**Curtis H. Stanton Energy Center
Combined Cycle Unit A**

Sufficiency Report

Re: Stanton Unit A Combined Cycle Project
Supplemental Site Certification Application
FDEP File No. PA 81-14SA2
DOAH Case No. 01-0416EPP
OGC Case No. 01-0176
Response to Statement of Sufficiency

**SEC COMBINED CYCLE PROJECT
WETLAND IMPACT AREA W5
DRAWING 98362-ERP-4A (04-17-2001)**

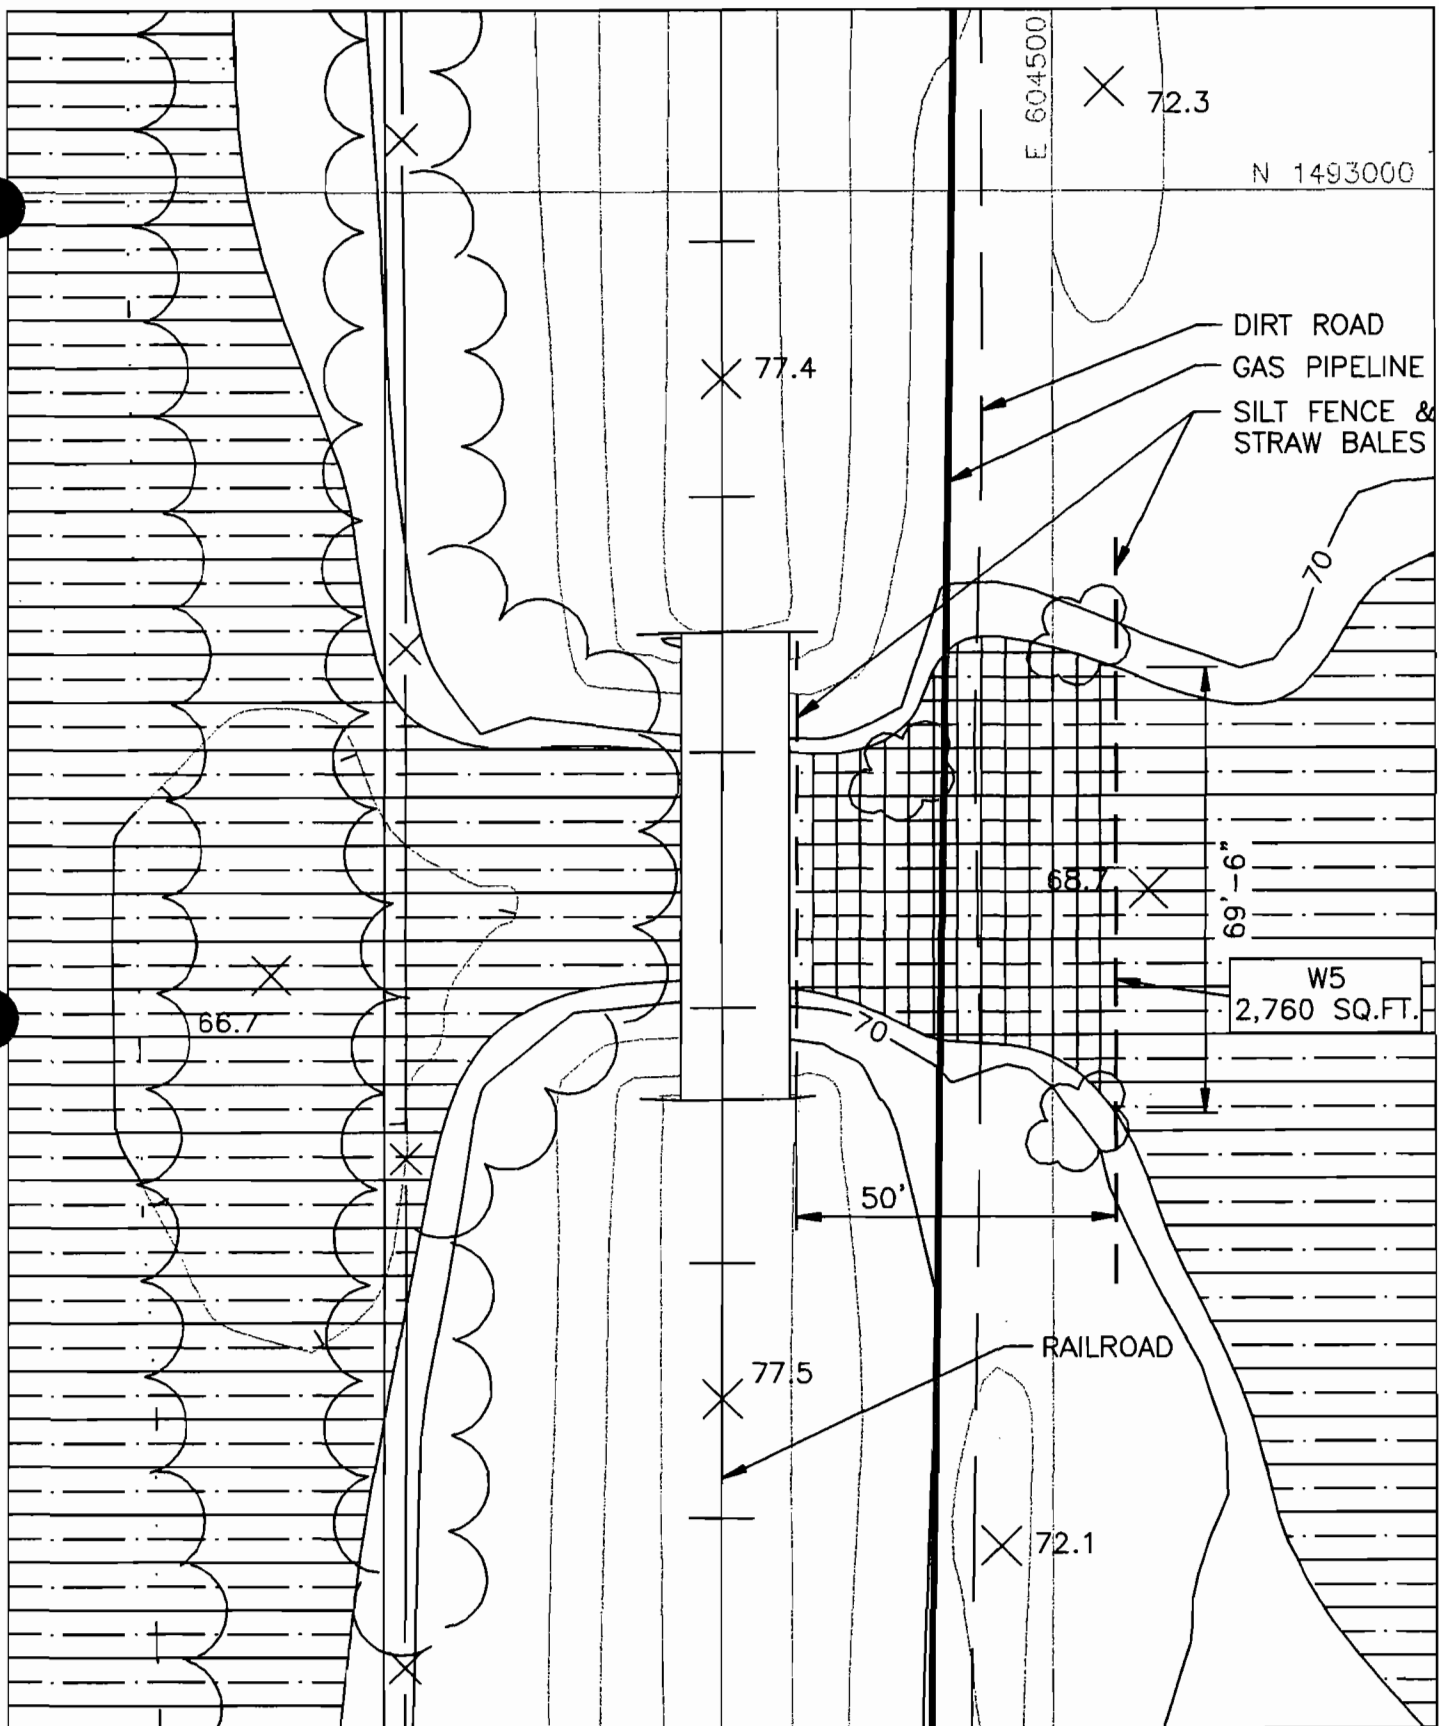
24. *ERP Drawing 98-362-ERP-4A reflects 2,760 square feet of wetland impacts to Wetland 5 (W5). Please explain why W5 impact (east of the existing roadway) is necessary.*

Response: Wetland impact area W5 would be a temporary impact to a previously disturbed, low quality herbaceous wetland and is required to install the natural gas pipeline. The wetland area spans the width of the corridor and cannot be reasonably avoided. Alternative installation techniques (i.e. directional bore) would not be cost effective for this small area. The temporary trench would be backfilled with the original excavated material, returned to original contours, and allowed to revegetate to an herbaceous or emergent cover.
